Appl. No. 10/707,246
Response Dated December 1, 2005
Reply to Office Action Dated September 2, 2005

Amendments to the Drawings:

REMARKS/ARGUMENTS

FIG. 5

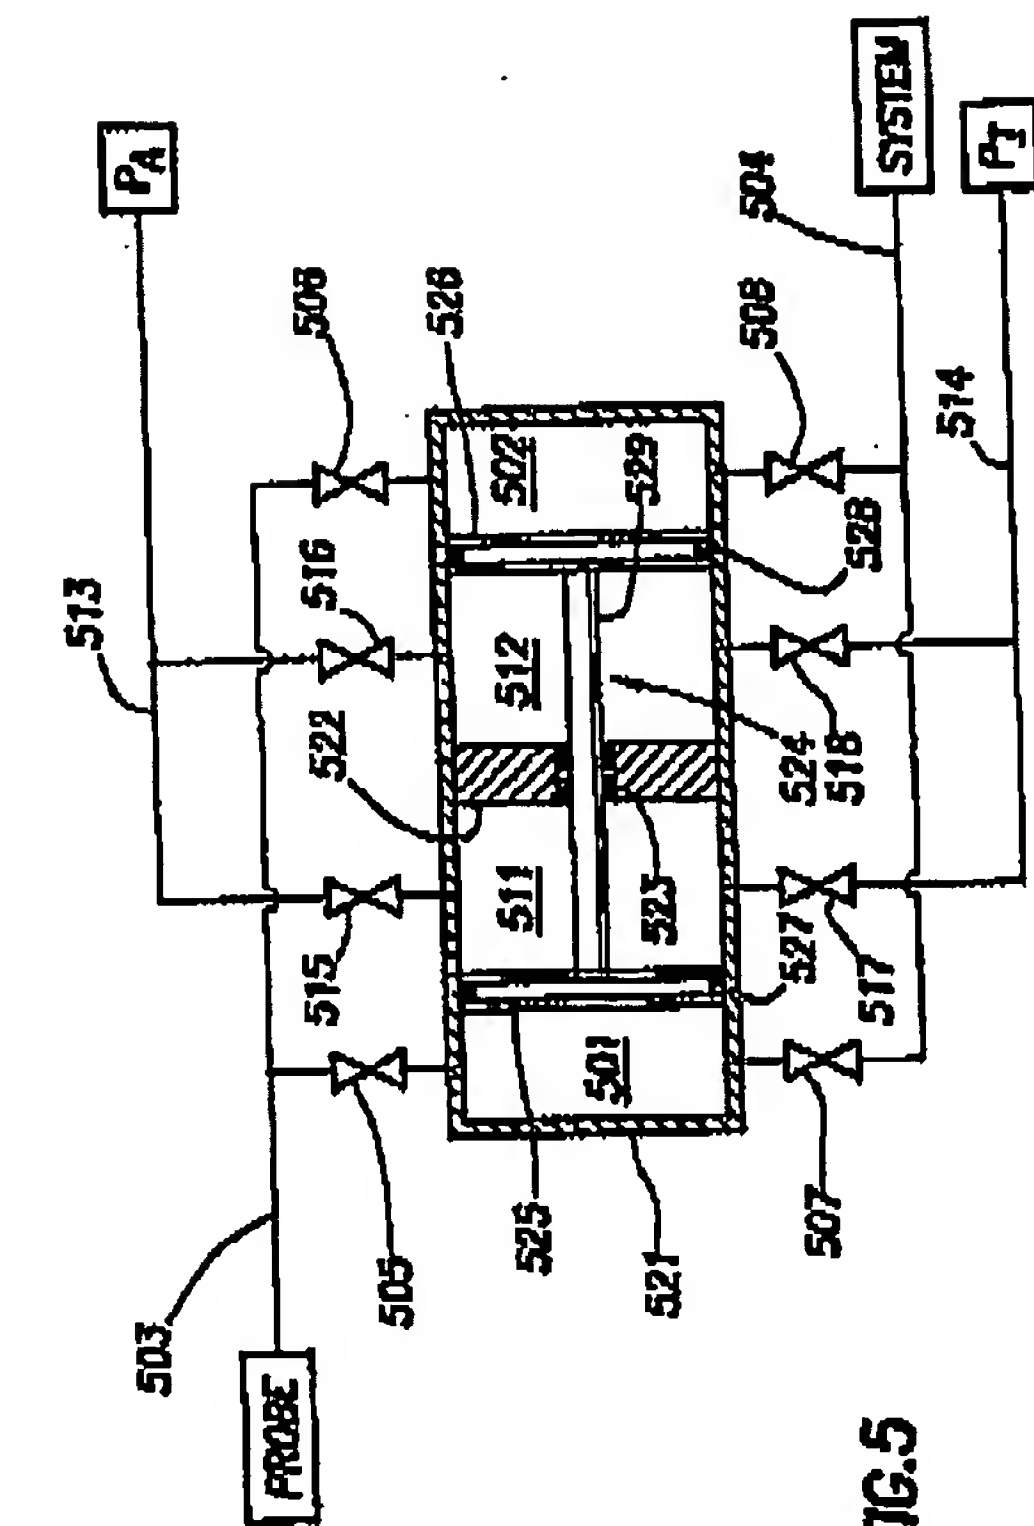
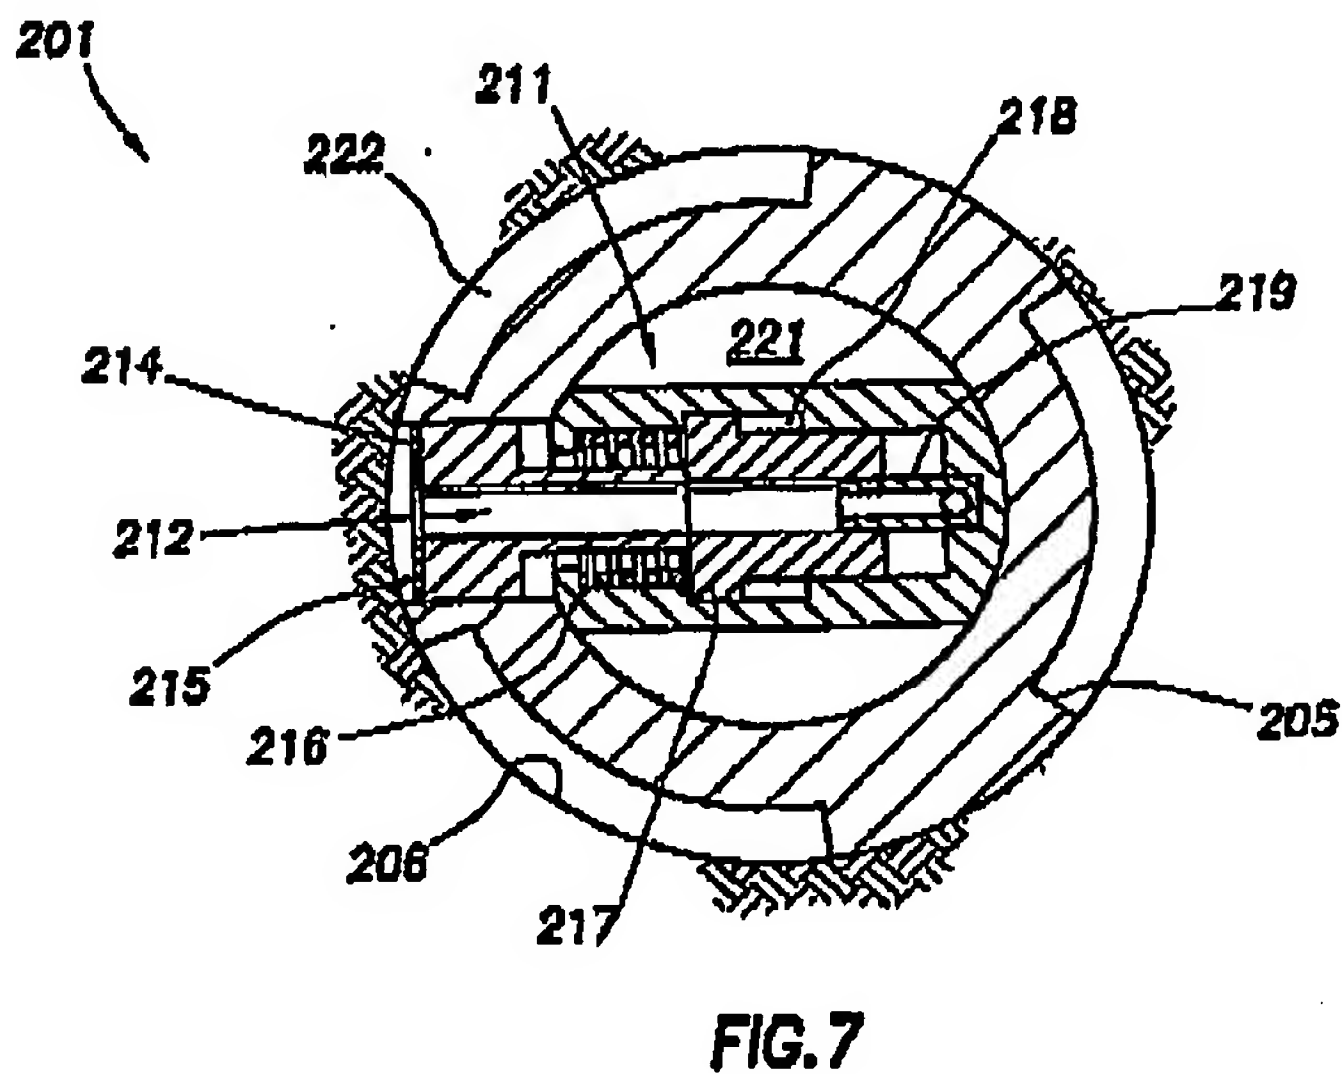
The attached sheet of drawings includes changes to Figures 4 and 5. These sheets, which include Figures 3, 4, 5 and 7, replace the original sheets including Figures 3, 4, 5 and 7. In Figure 5, the duplicate use of reference character 501 is being corrected by changing the reference character "501" on the far left of Figure 5 (used in association with an arrow) to refer to the pump "500." In Figure 4, reference number 421a has been deleted.

Applicant has also submitted replacement paragraphs 59-60 and 65-66, along with a replacement drawing sheet 3/6 including new Figure 5, to remove the duplicate use of reference character 501 and to correctly refer to the pump as "pump 500." Replacement paragraph 79

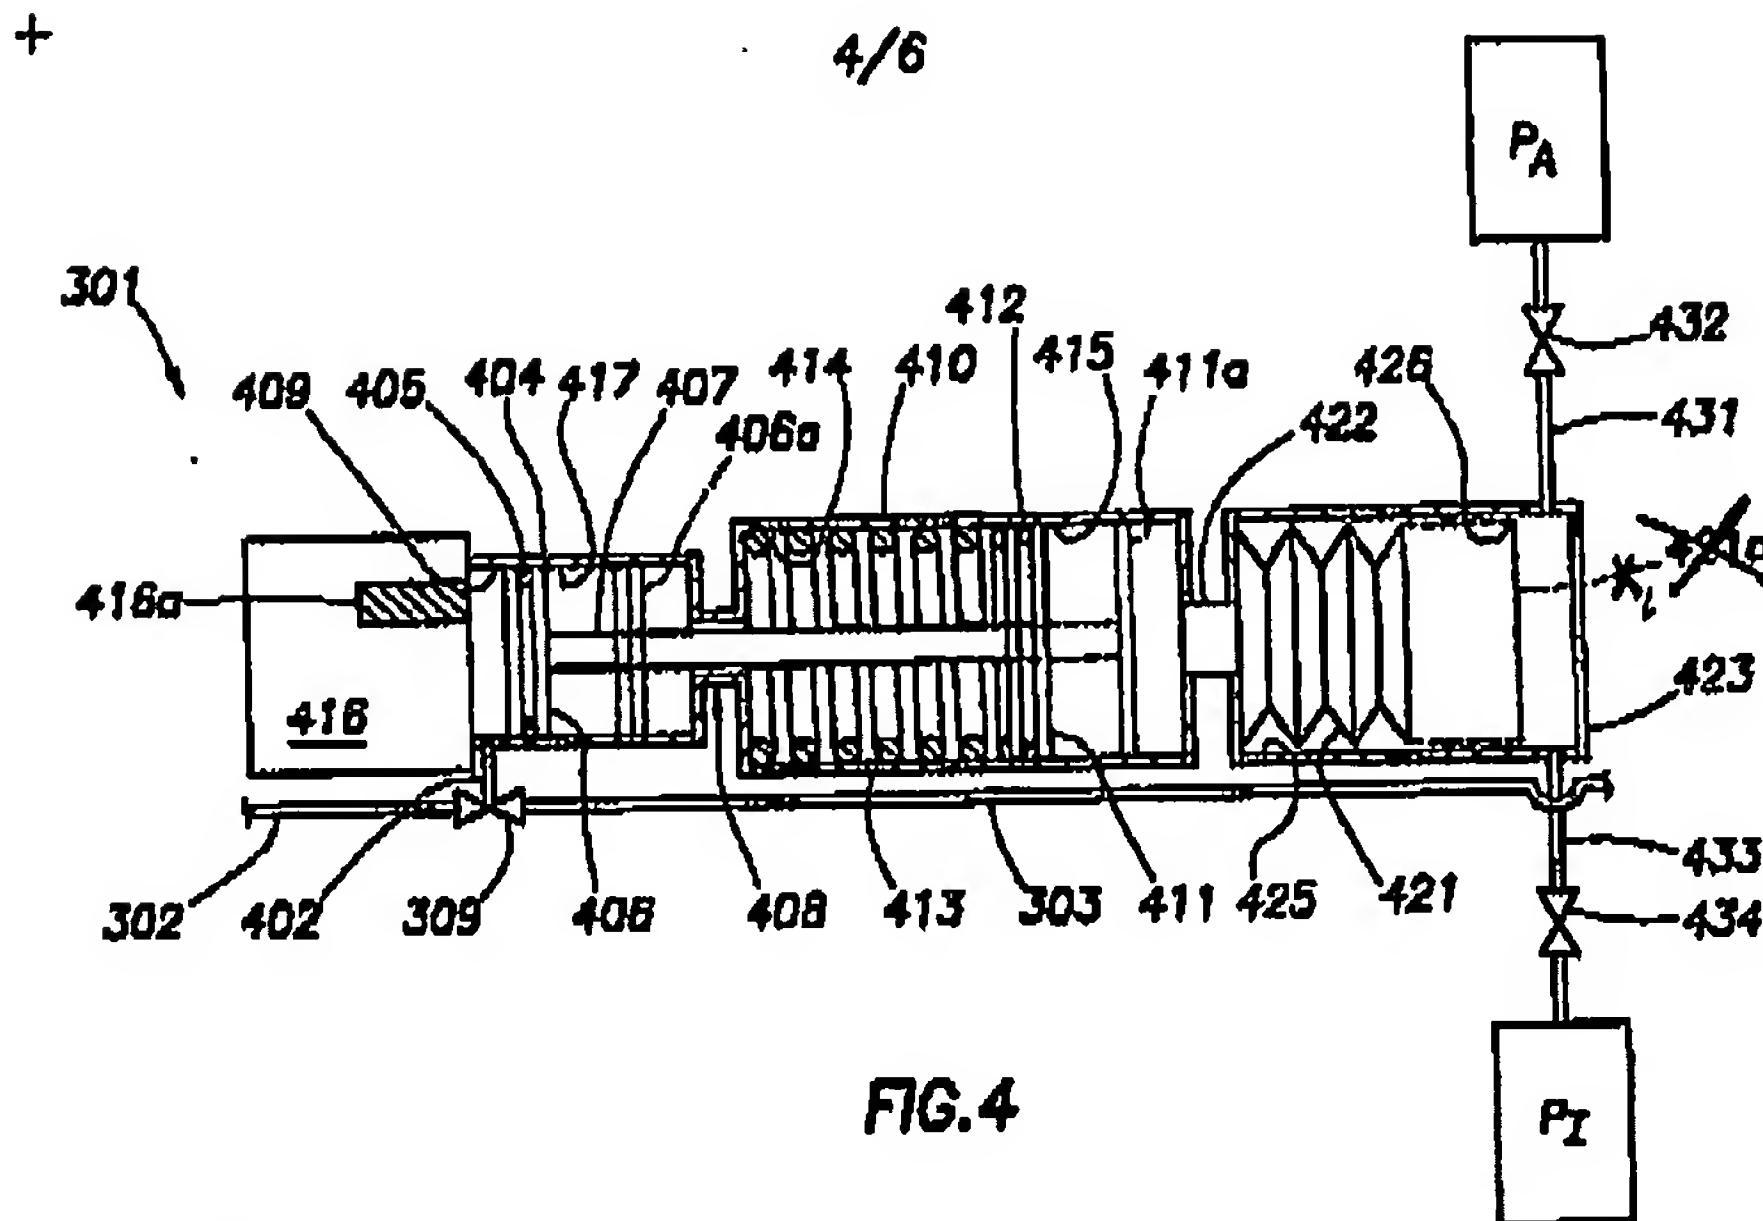
The Examiner "objected to the drawings as failing to comply with 37 CFR 1.84(p)(5) because they include the following reference character(s) not mentioned in the description: 527, 528 (fig. 5); 421a (fig. 4); and 705 (fig. 8B)." Applicant has submitted a replacement drawing sheet 4/6 including new Figure 4, to remove the use of reference character 421a. Applicant has also submitted replacement paragraphs 58 and 88 to include the reference characters 527, 528 and 705 in the description. Support for the amendment to paragraph 58 is found in Figure 5. Support for the amendment to paragraph 88 is found in Figure 8B step 705. No new matter has been added by way of these amendments. Reconsideration and withdrawal of the objection is respectfully requested.
